## WESTERN NUCLEAR, INC.

**SUBJECT: Source Material License SUA-56; License Conditions 24 and 74.**

## MEMORANDUM

**TO:** Larry Corte, WNI  
**FROM:** Lou Miller, P.E.  
**DATE:** February 12, 2004  
**SUBJECT:** Response to NRC Letter -- Item 4

**FIGURE 1**  
**EXISTING AND PROPOSED**  
**MONITORING WELLS**

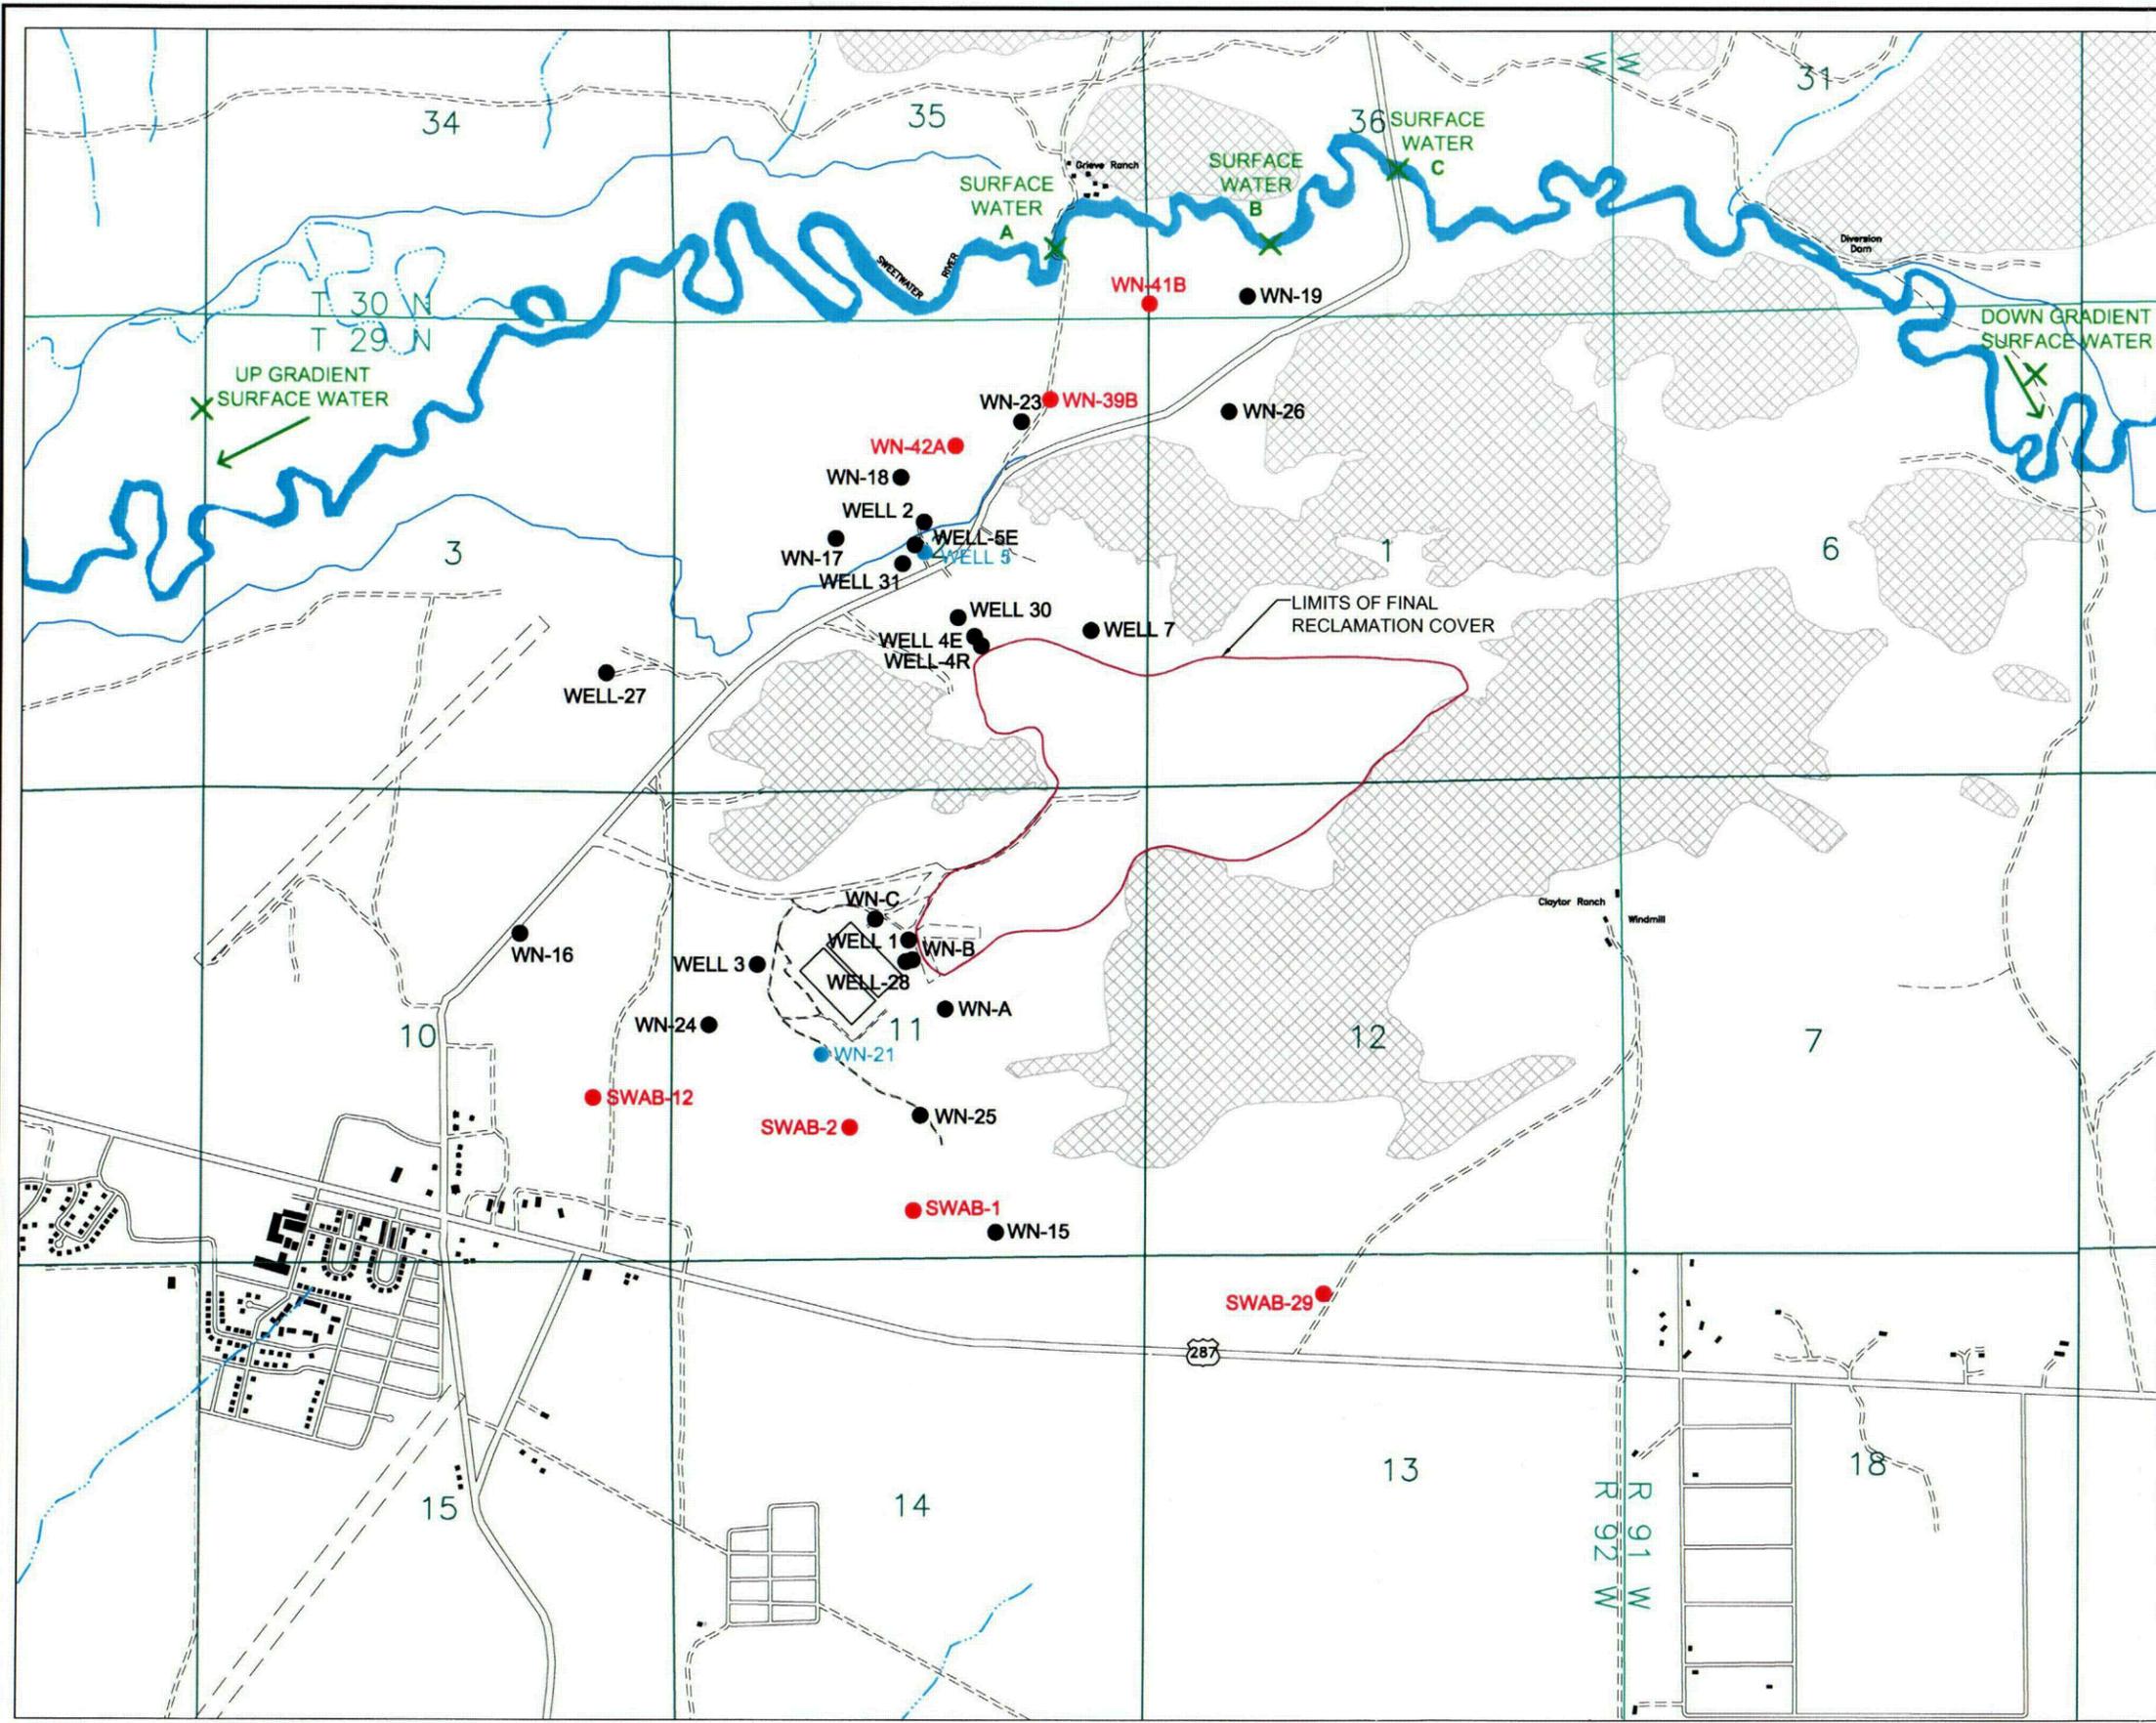
A new groundwater and surface water monitoring program is proposed. This system is designed to better monitor evolution of the groundwater plume and to provide more detail for the surface water monitoring program. The location of the existing monitoring locations and the new proposed locations are shown on Figure 1.

The wells that are part of the existing monitoring requirements are generally close to the tailings impoundment and are not useful in defining the continued evolution of the contaminant plume. The new proposed wells will be able to monitor the plume as it matures. Data from the proposed wells could be used to evaluate the plume development with the modeled results.

Point of compliance (POC) wells, proposed in the October 1999 groundwater report (SMI, 1999), are Well 5 and Well WN-21. The proposal for these wells to be the POC wells remains the same.

Two new points have been added to the surface water sampling system. These points are labeled Surface water B and C. They supplement the existing sample location A to better monitor water in the Sweetwater River that might be impacted from the contaminant plume.

The licensee shall sample five surface water locations as shown on Figure 1 of its February 16, 2004 submittal. Samples will be taken annually and analyzed for uranium and sulfate. The results shall be submitted to the NRC as soon as practical after the results are obtained.

A. Sample wells WN-41B, WN-39B, WN-42A, SWAB-12, SWAB-2, SWAB-1 and SWAB-29 on an annual frequency for uranium, sulfate and water levels. Sample wells 5 and 21 on an annual basis for aluminum, arsenic, beryllium, cadmium, fluoride, manganese, molybdenum, nickel, ammonia, nitrate, lead, radium-226 and 228, antimony, selenium, thorium-230, thallium and uranium and water levels. The results of the groundwater monitoring program shall be submitted to the NRC as soon as practical after the results are obtained.

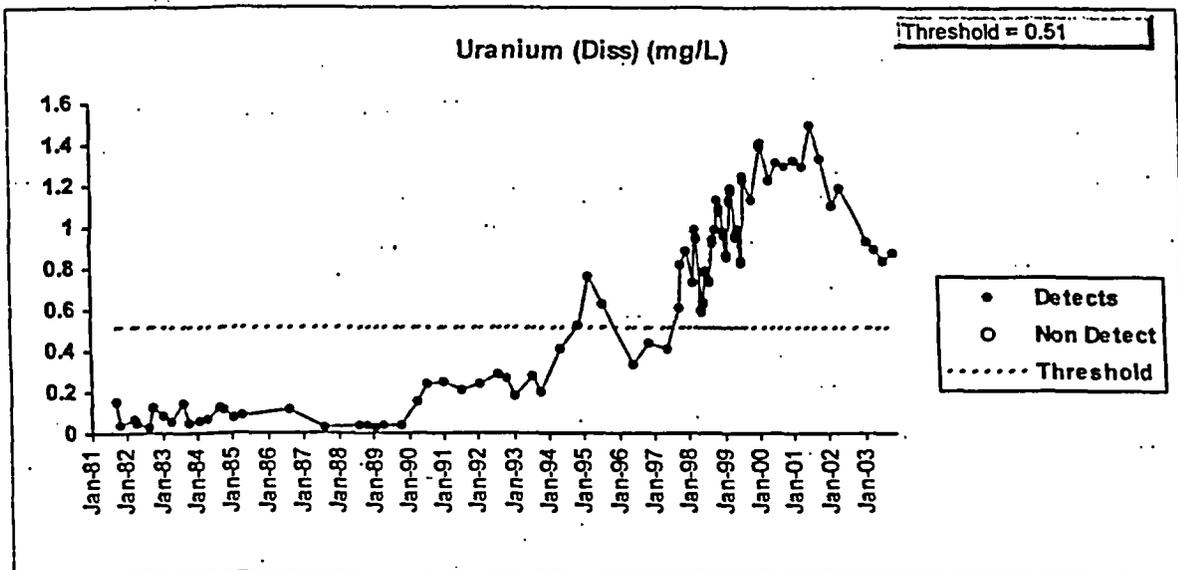
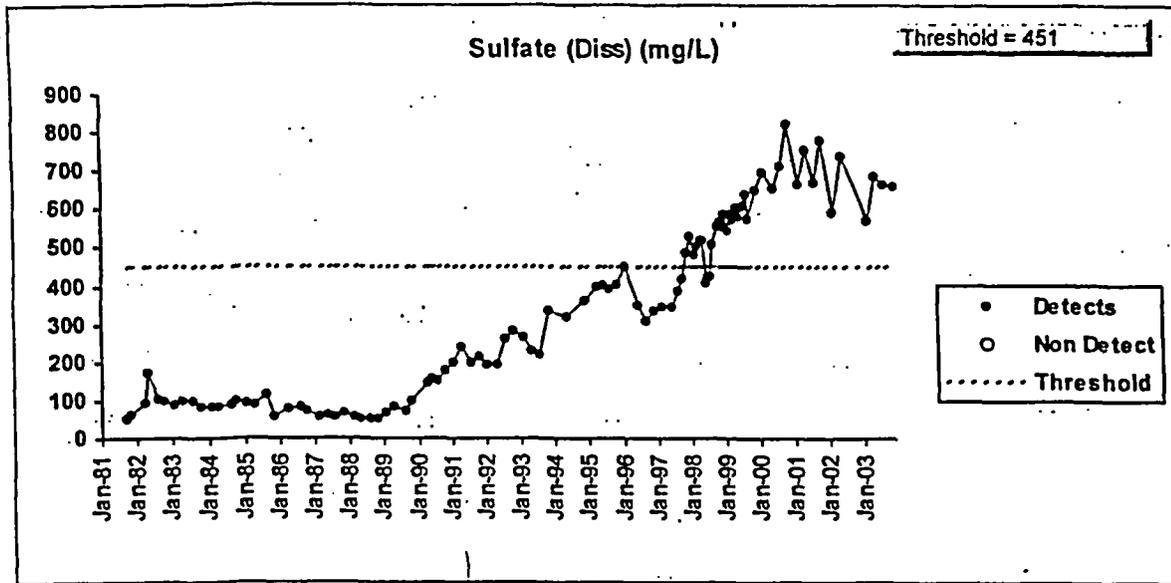
The existing monitoring is performed on a quarterly basis. These results have been submitted on a semi-annual basis. The results of the historic sampling clearly indicate that groundwater quality changes occur very slowly. As an example of this, Figures 2 and 3 show historical water quality data from wells WN25 and WN-18. These wells are in the contaminate plume and are in the same general areas the propped monitoring wells. Results from these wells clearly show that annual monitoring would be sufficient to adequately monitor the changing conditions within the contaminate plume. Some seasonal variability is evident in the Northwest valley wells completed in the Sweetwater River floodplain. This is due to the effects of irrigation and flooding and not due to changes in groundwater flow.
